### Dear Dealers,

As a result of continuous quality checks on the products in the field, together with your reports on the involved model, we have found that in some circumstances a Customer reports a difficult gear engagement due to excessive play in the gearchange lever adjustment slot where it attaches to the gearchange lever connecting rod (resulting from the loosening of the adjustment screw).

Figure A - Backside view

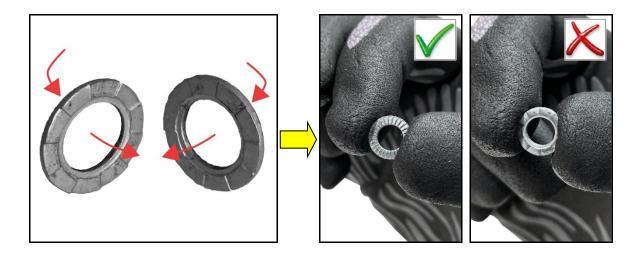
3. Remove circlip (2) from gearchange lever (1) retaining screw (3) M6x20 (Figure A). Loosen gearchange lever (1) retaining screw (3) M6x20 (Figure B). Collect self-locking nut (4) M6 (Figure C).
